RFQ 2FY20 Vendor Question 24

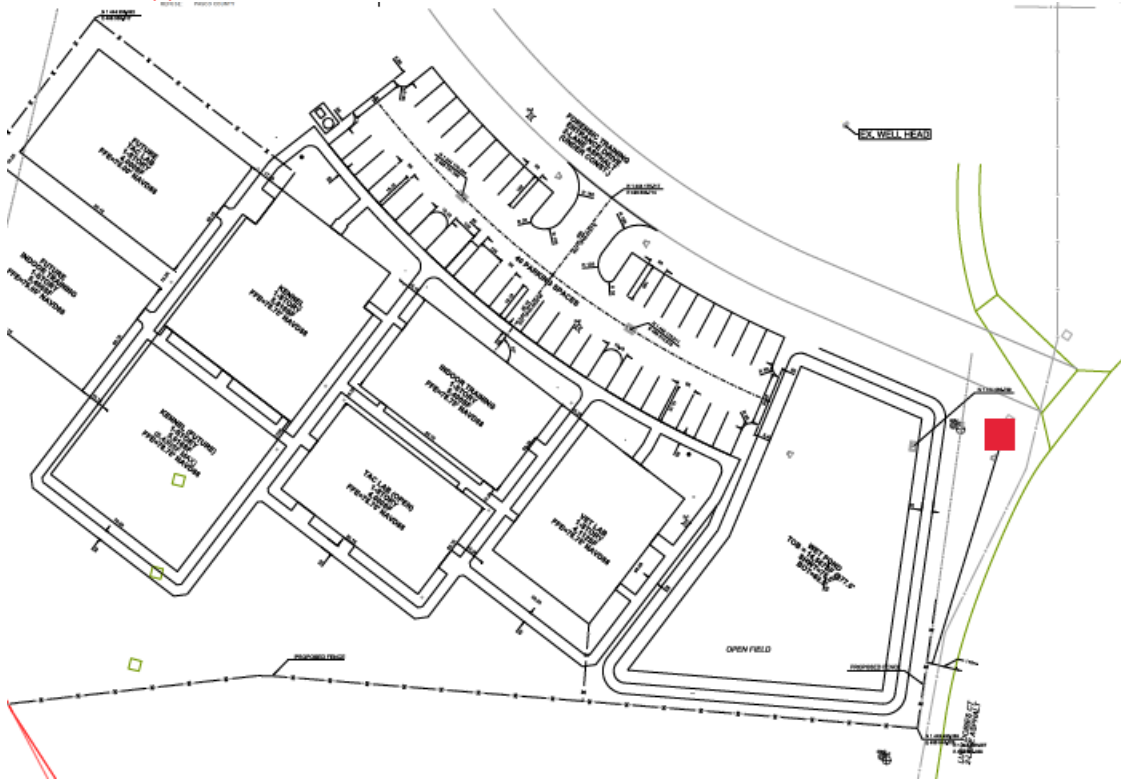
1. Civil plans do not show location of primary power supply/transformer(s). Without the location of the primary power supply to each building we cannot determine length of run for secondary power supply. Please provide transformer/primary power supply location for each building or length of secondary power supply run to be included in bid for each building?

Please see approximate location of transformer below.
